# PERMIT

SEWAGE DISPOSAL SYSTEM

A REPAIR

SUBDIVISION \_\_\_\_\_ ROAD 6302 Trotter Road LOT \_\_\_\_\_

P 31034  
Repair

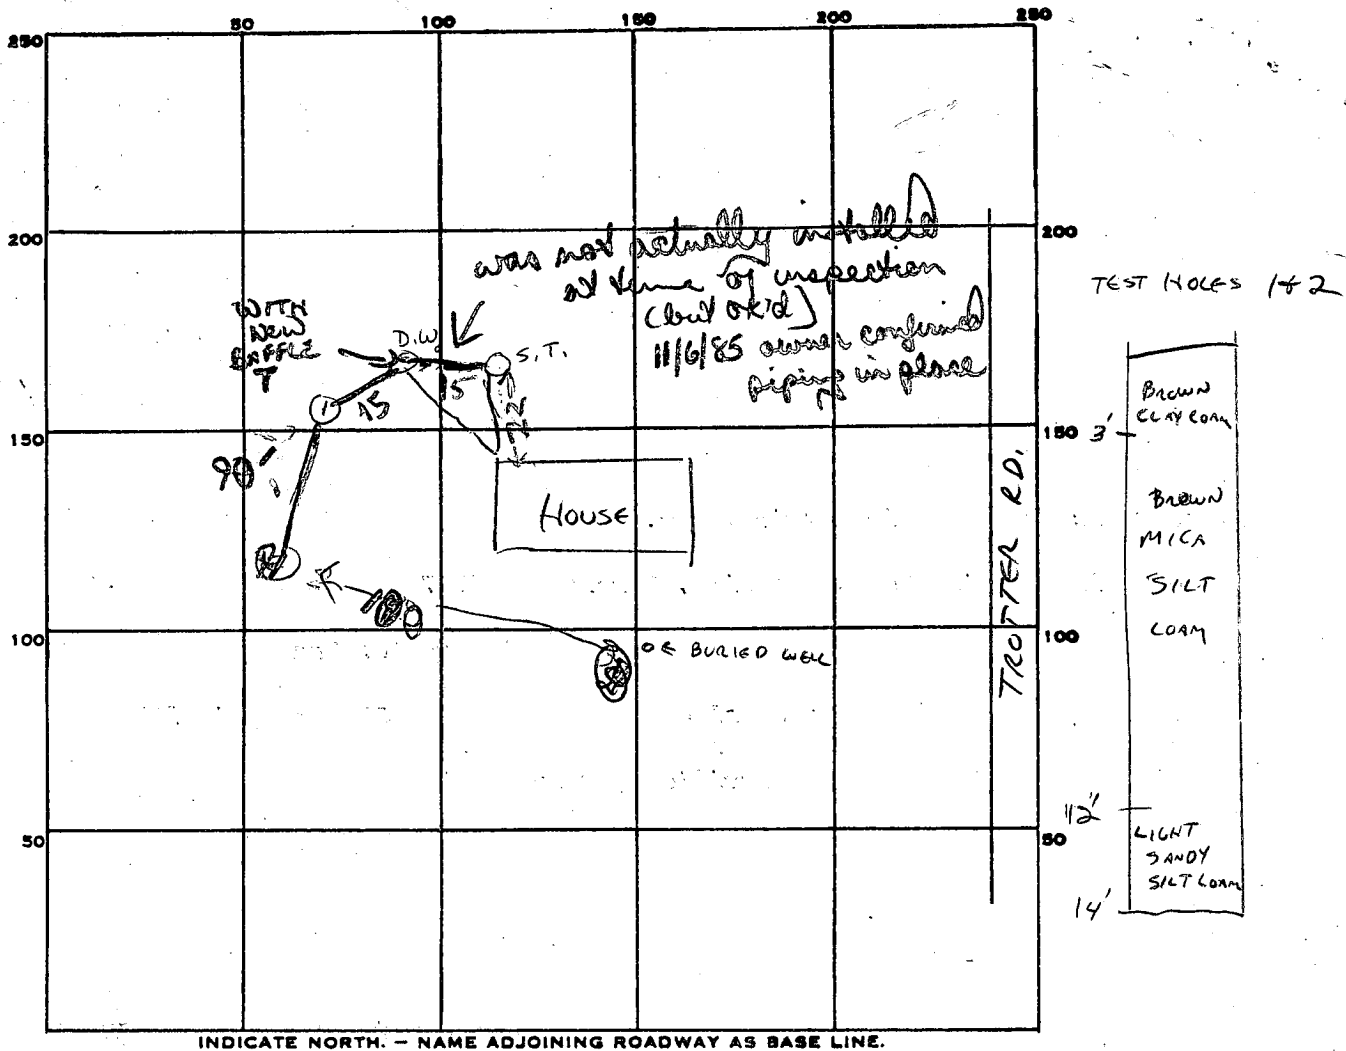
KITCHEN + LAUNDRY WATER PIPED DIRECTLY TO DRYWELL. INSTALL OUTLET PIPE

ON DRYWELL OR REPIPE KITCHEN + LAUNDRY INTO SEPTIC TANK,

INSTALL NEW TRENCH 60' LONG WITH 6" STOVE, C.W.

REMARKS 10/7/85 INSTALL MINIMUM OF 60' TRENCH - INLET 4'; BOTTOM 10'; CONNECT TO EXISTING DRYWELL

WITH OUTLET BAFFLE ADDED IF WASH + KITCHEN WATER IS TO REMAIN DIRECTLY PIPED TO DRYWELL.

10/9/85 303PM Stone, piping + paper in trench - OK to cover  
 need to come back + recheck for new cleanouts  
 on S.T. + D.W. OK TO COVER SYSTEM +  
 INSTALL CLEANOUTS + CALL RH BN

CLEANOUTS will build up new cleanouts on both S.T. + D.W. to ground level

11/15/85 -  
 CONV WITH OWNER -  
 BAFFLES AND CLEANOUT  
 ADDED TO DRYWELL.  
 CW

DATE SYSTEM APPROVED 11/6/85 NO c/o 11/15/85 owner has specs + is to install himself. Is aware that we need to see completed  
 INSPECTOR [Signature]
